**Bridge Scour Investigation
and
Design of Corrective Measures**

**Contract No. CY 1997-26
Work Order No. 80407**

Final Report

Deer Valley Road Bridge at Wash (189th Avenue)

DEER VALLEY ROAD BRIDGE @ 189TH AVENUE

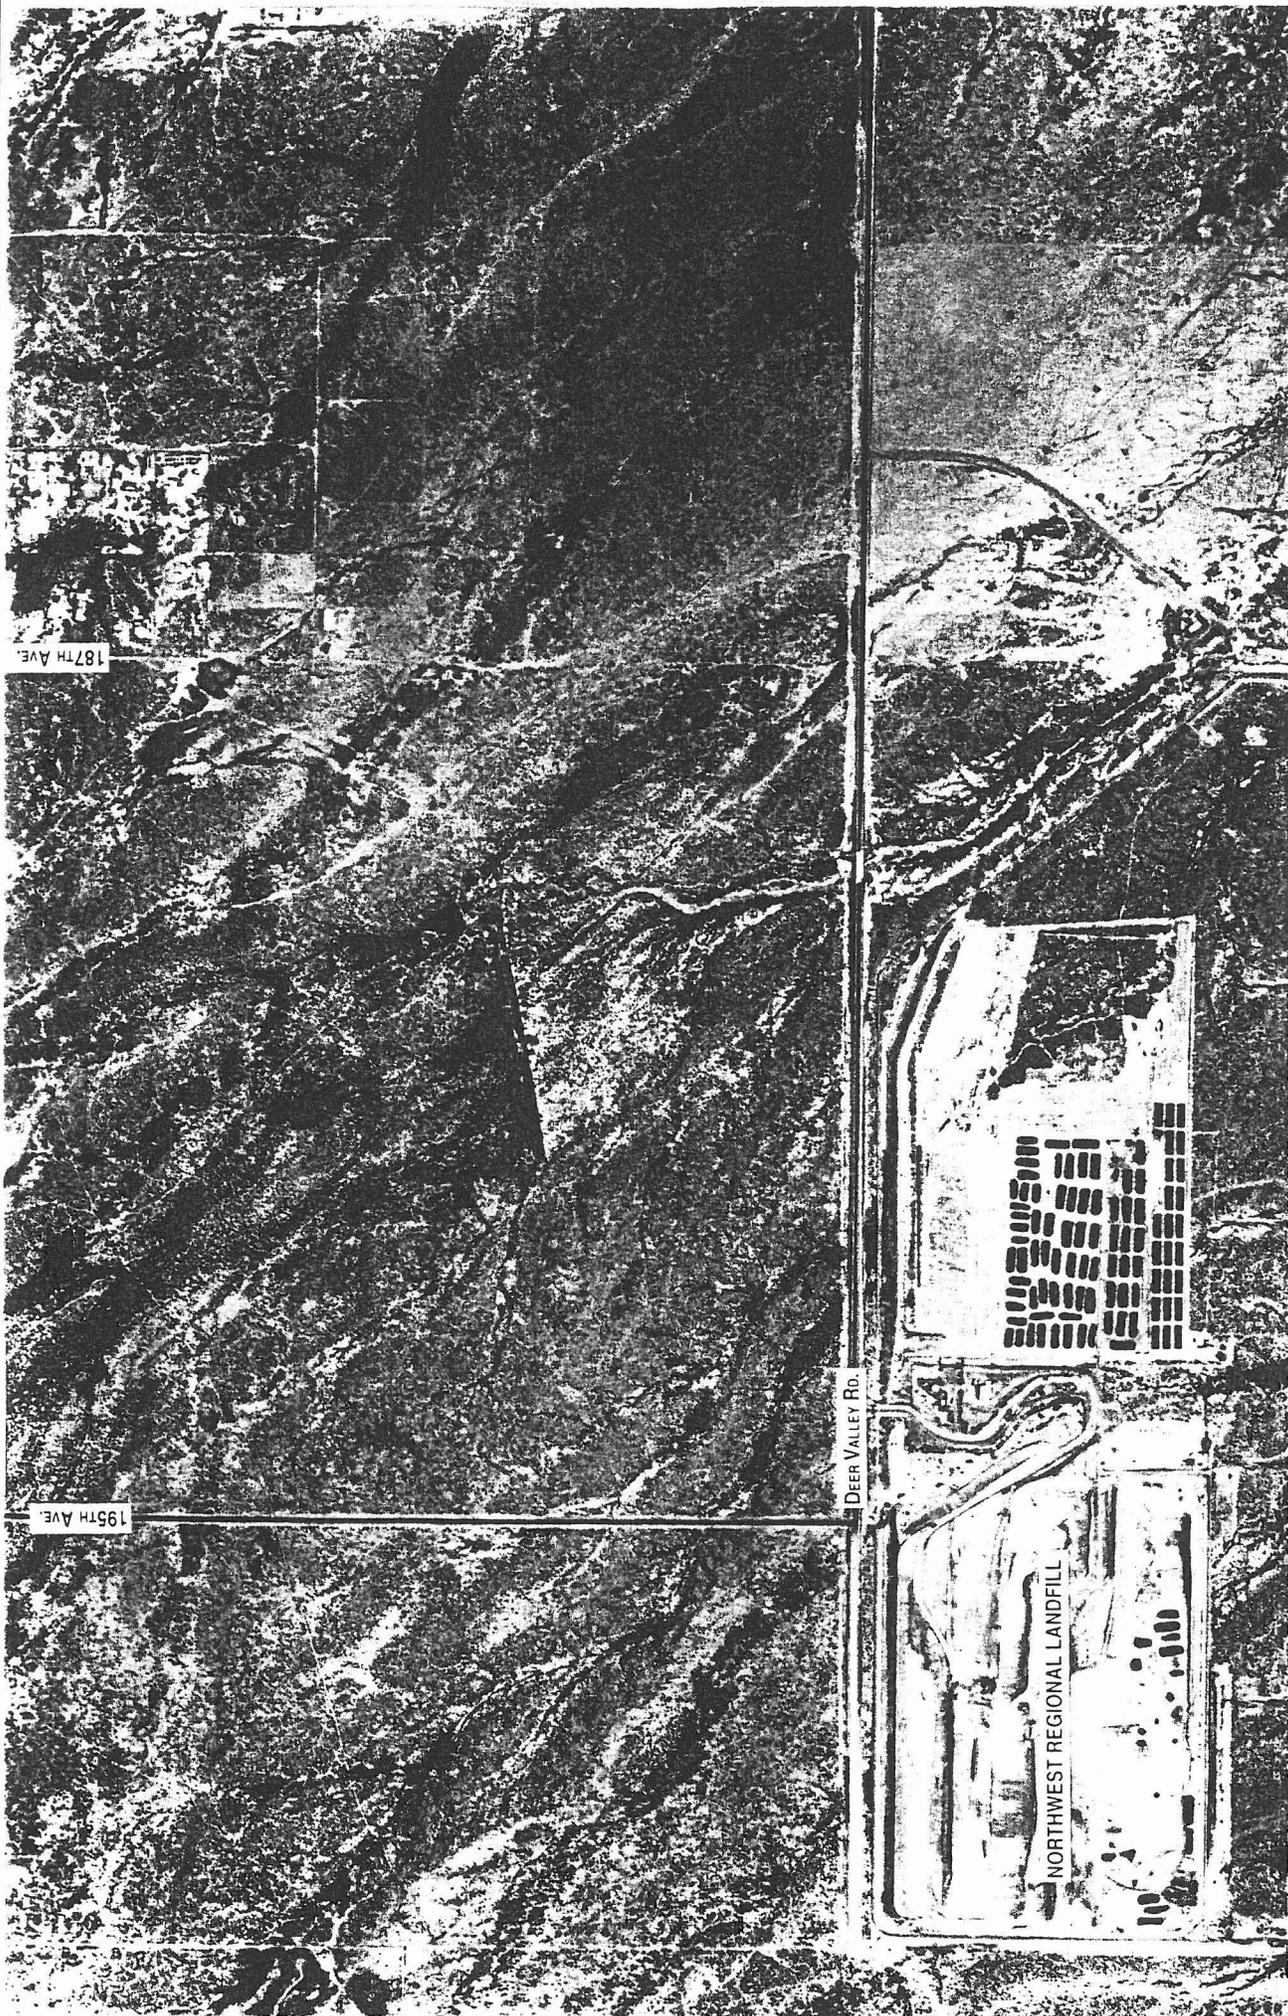
- The Report does not contain local ground elevations in order to determine if the larger flood flows will remain in the wash channel or sheet flow across the desert floor.
- There is a significant channel paralleling Deer Valley Road which diverts a significant amount of discharge from washes to the west of the bridge location. Although the existence of this channel and the fact that it diverts additional flow to the bridge site is noted in the report, no attempt seems to have been made to quantify this discharge. The discharge in this channel could significantly increase the west abutment scour. (See page 4)
